GRID CODE Modification Proposal

Active power recovery after fault ride through events in respect of Large Power Park Units

| Issue | V1.0 |
| Date of Issue | 8 th September 2010 for GCRP meeting 23 rd September 2010 |

Figure 1: Measurement of a Voltage Drop to 4%, 140ms, full load

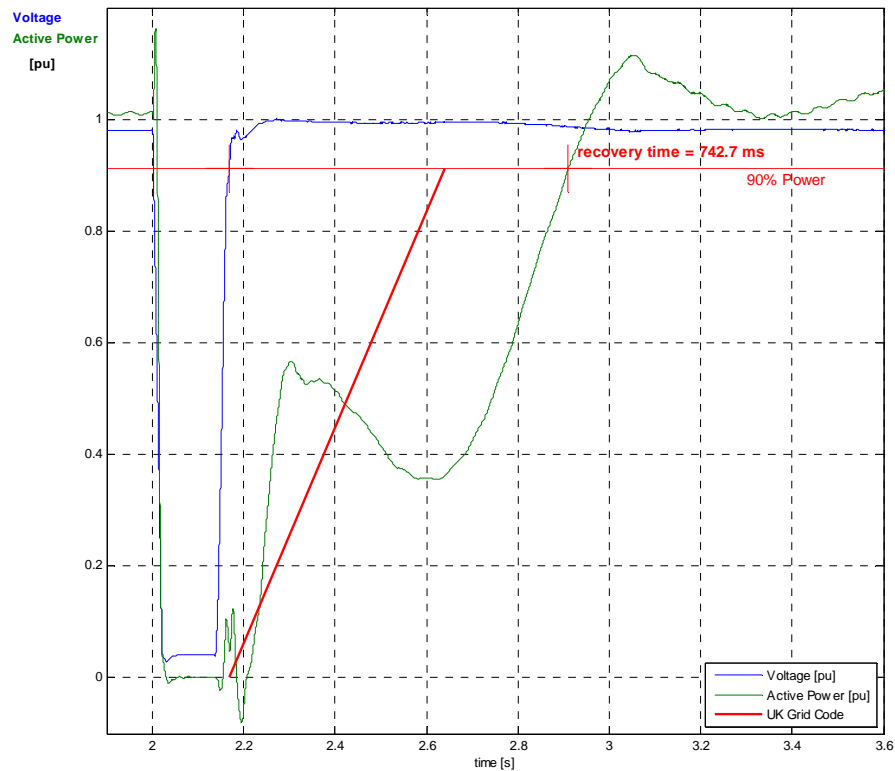
Current information about power park units using long-shafts technology suggest a reverse relationship i.e. units exposed to longer less severe fault are capable to recover their active power quicker than units exposed to short severe faults (see example measurements in figure 1 and 3). It is expected that a similar relationship is existing for all PPU technology using long shafts, where blade mass, gearbox and generator are able to oscillate. However, there is not sufficient data available at this point in time.

Figure 3 Current available wind turbine technology

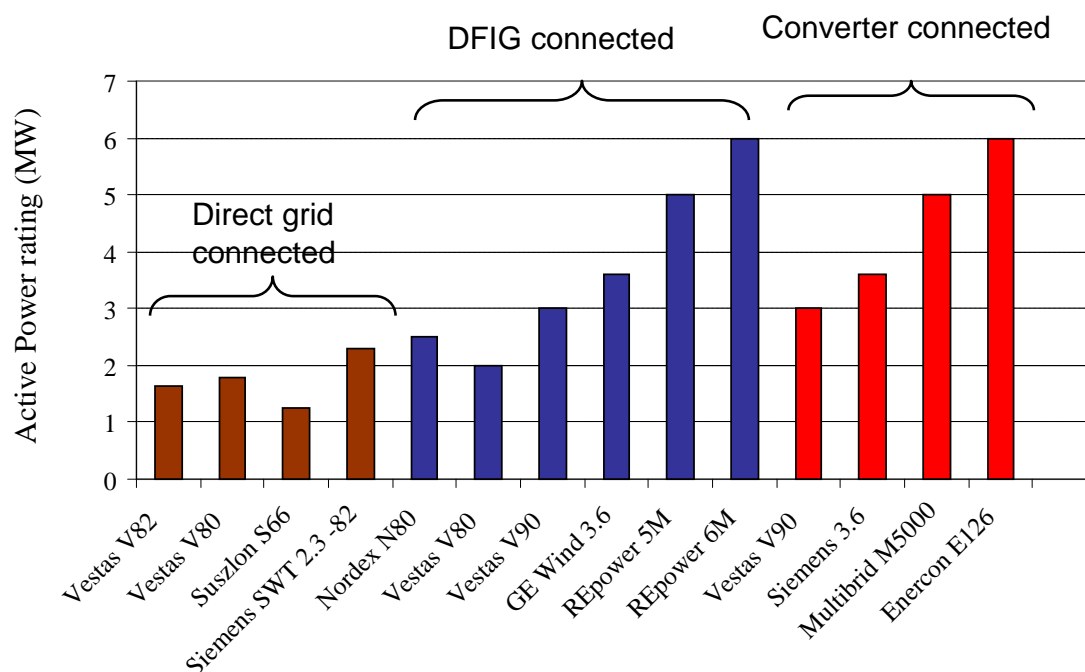
Insisting on 0.5 second recovery leads due to the inherent effect within the technology to discrimination of PPU's with long shaft technology and to become grid code non compliant through upscaling. This consequently might have an impact on the availability of large wind turbines to fulfil UK's renewable energy targets. See Figure 3 for an overview of the current existing PPU's dependant on their grid connection. It is to note, that most current wind turbines are using long shaft technology.
